DATE: November 16, 2007
TO: City Manager
FROM: Planning & Development Services Department
APPLICATION NO. DP07-0039 **APPLICANTS:** Tessco Inc.
 DVP07-0040
AT: 1933 Ambrosi Road **OWNER:** 1314696 Alberta Ltd.

TO OBTAIN A DEVELOPMENT VARIANCE PERMIT IN ORDER TO VARY THE FOLLOWING DEVELOPMENT REGULATIONS: MAXIMUM SITE COVERAGE, MAXIMUM HEIGHT, MINIMUM FRONT YARD SETBACK, MINIMUM REAR YARD SETBACK, MINIMUM SIDE YARD SETBACK, AND MINIMUM NUMBER OF VISITOR PARKING STALLS.

2.0 SUMMARY

The applicant is seeking approval of a 72-unit apartment building. The Development Permit application addresses the form and character of the proposed building, while the Development Variance Permit application is needed to deal with those development regulations conflicts detailed in the table on page 3 of this report.

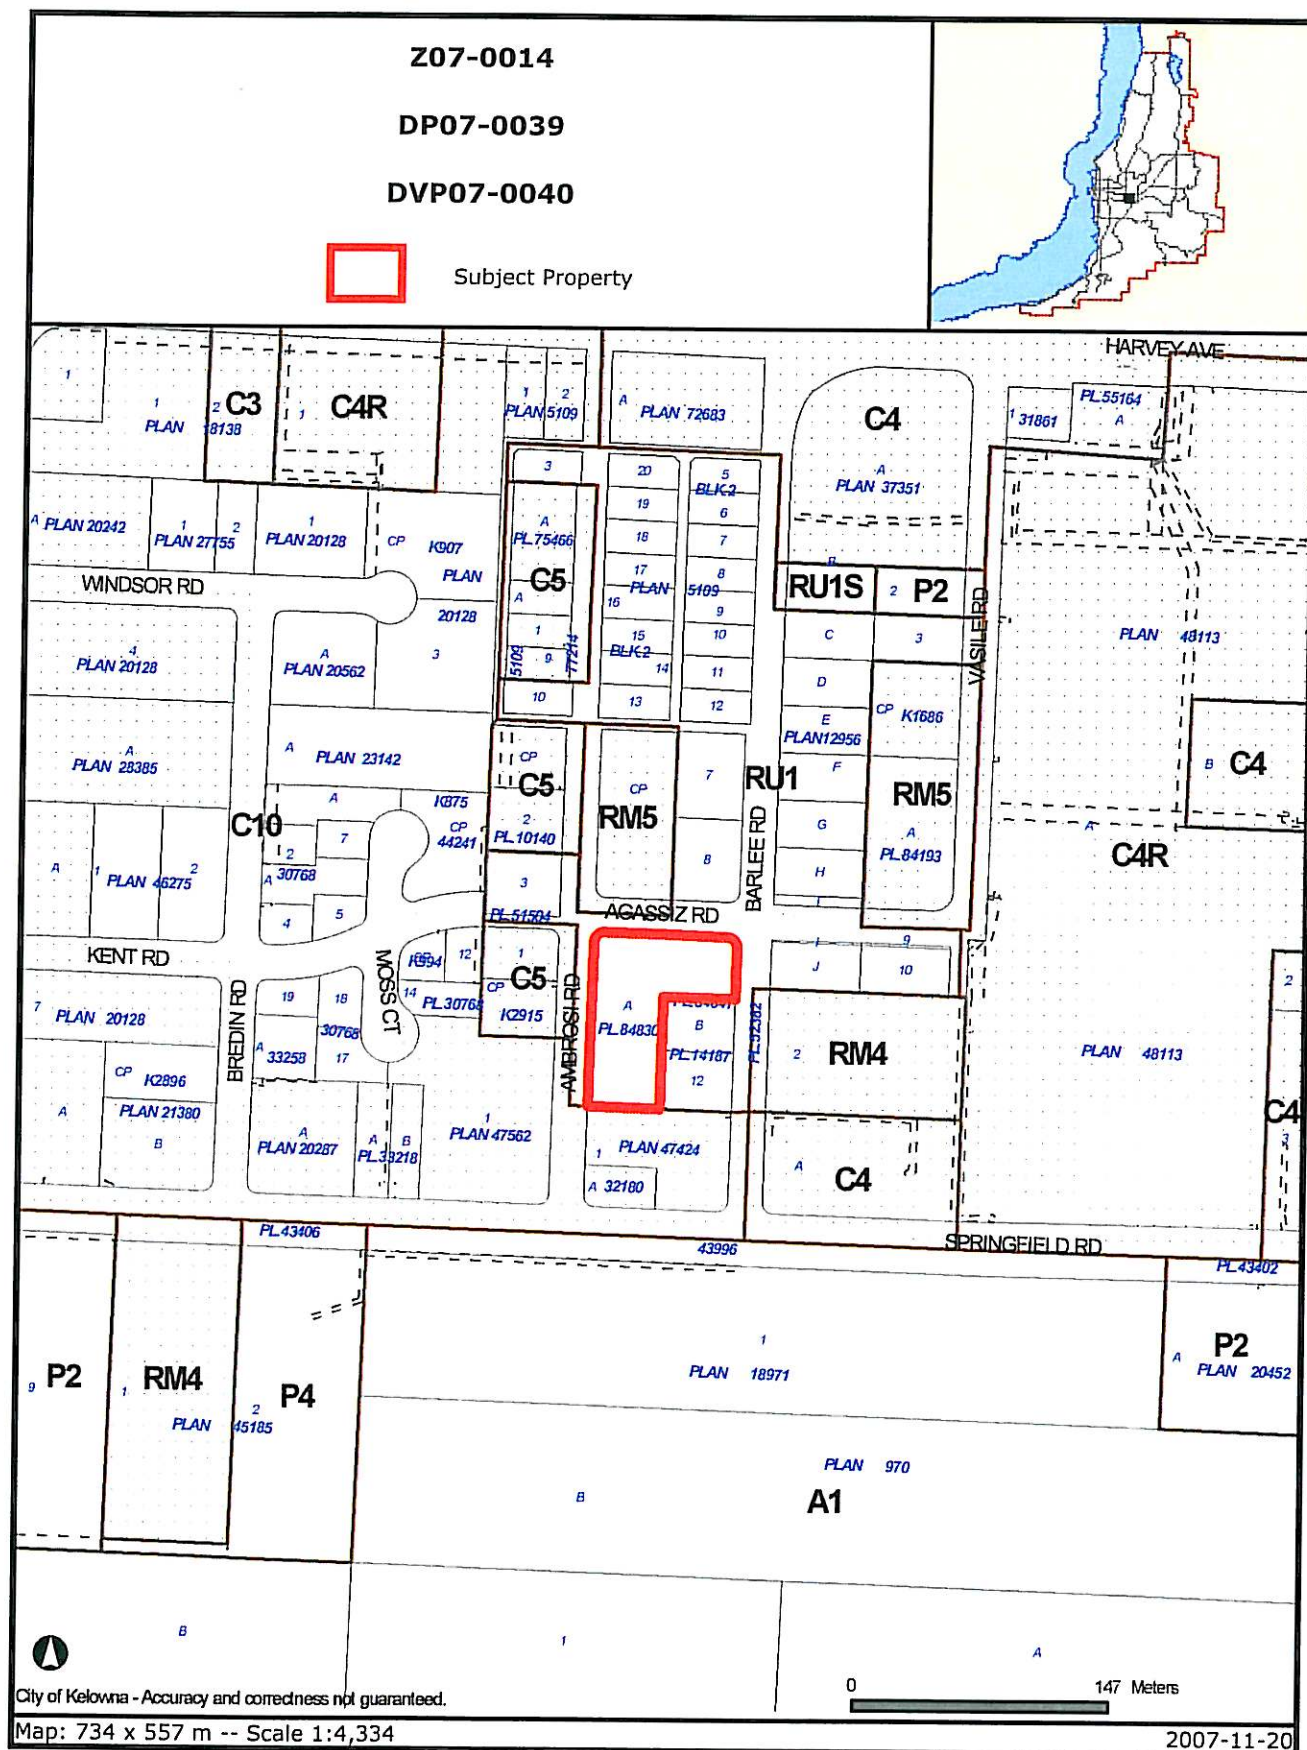
It should be recognized that some of the attached drawings do not reflect the project entirely. For example, the rendering does not capture the extent to which the parkade will extend above grade. Furthermore, at the time of writing this report, Staff did not have updated building section drawings that would illustrate this further.
